To: Kristopher Byrd, Well Construction and Compliance Section Manager
From: Travis Kelly, Well Construction Program Coordinator
Subject: Review of Water Right Application G-19188
Date: September 21, 2021

Groundwater Application Review Summary Form

Application # G- 19188

TO: Water Rights Section Date 9/17/2021
 FROM: Groundwater Section Jen Woody
 Reviewer's Name
 SUBJECT: Application G- 19188 Supersedes review of n/a
 Date of Review(s)

Figure 3. Water-Level Measurements in Nearby Wells

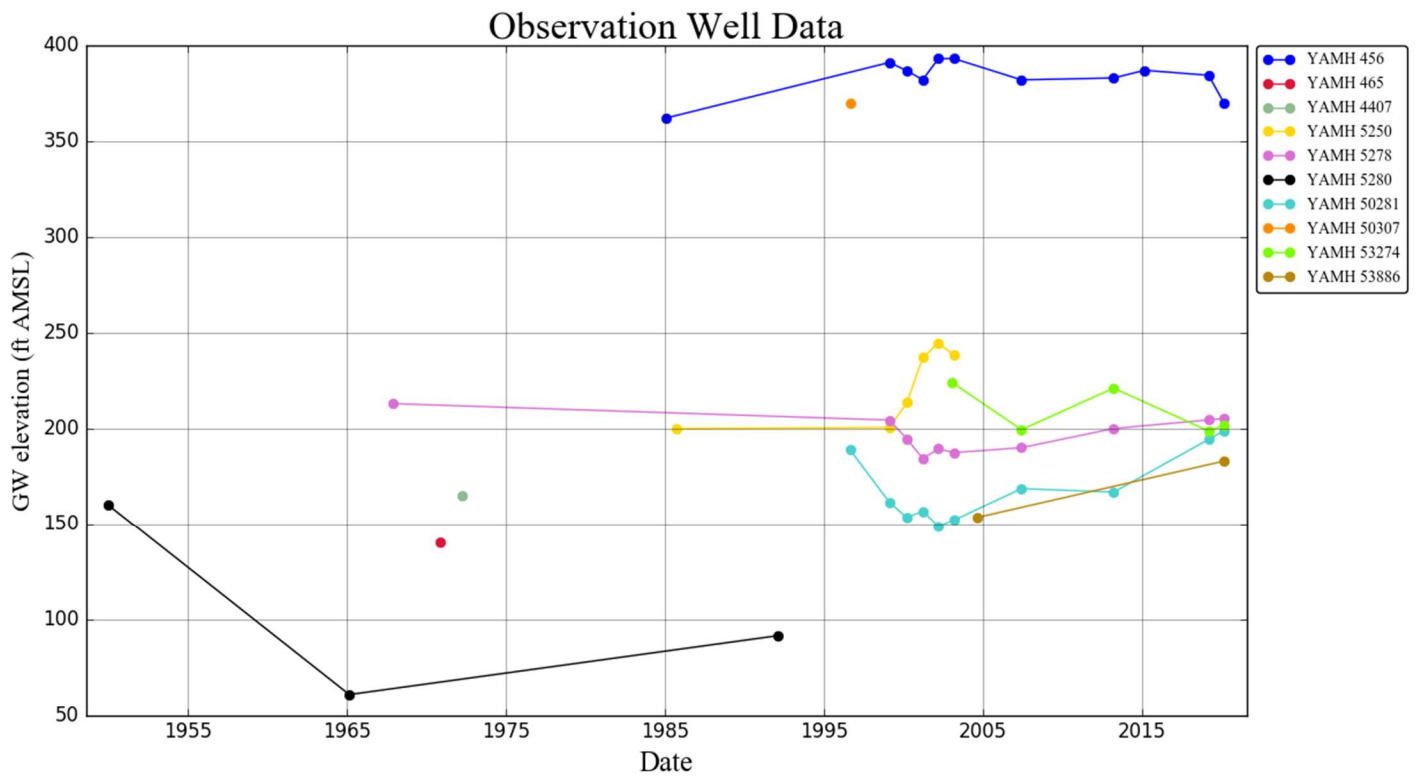
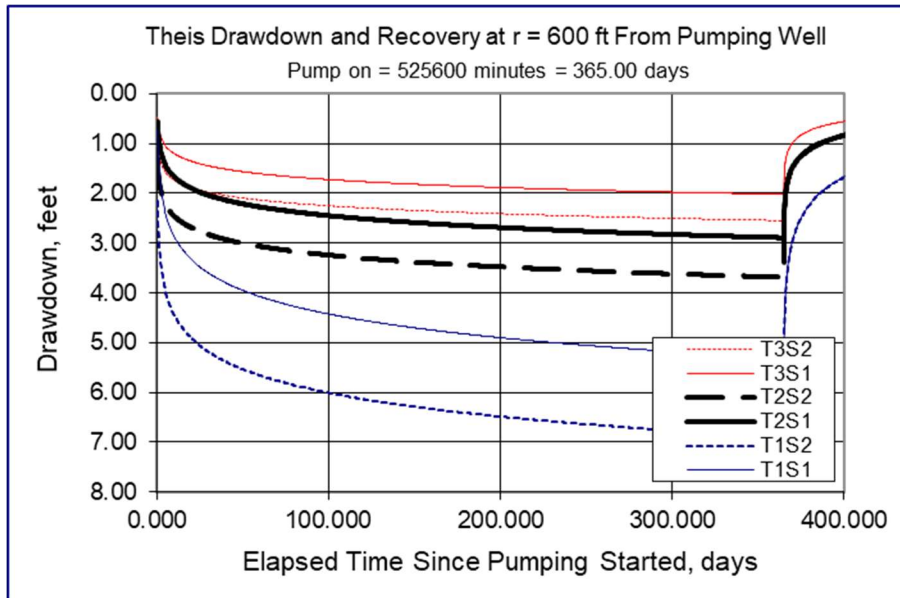
While there are not enough data available to determine over-appropriation, nearby wells associated with the subject property show relatively stable groundwater levels under the current level of use (See Figure 3). The closest wells are owned by the applicant, and will be the most affected by drawdown interference resulting from this application’s proposed use. At a distance of 600 feet from the pumping well drawdown is expected to range from 2 to 7 feet after 365 days of pumping at the maximum proposed rate. This is not expected to prevent nearby reasonably efficient and fully penetrating wells from accessing water. Water level monitoring and reporting is already conducted at the subject well for Permit G-18557, but this permit, if it is issued, should contain monitoring and reporting conditions specific to the new proposed industrial use.
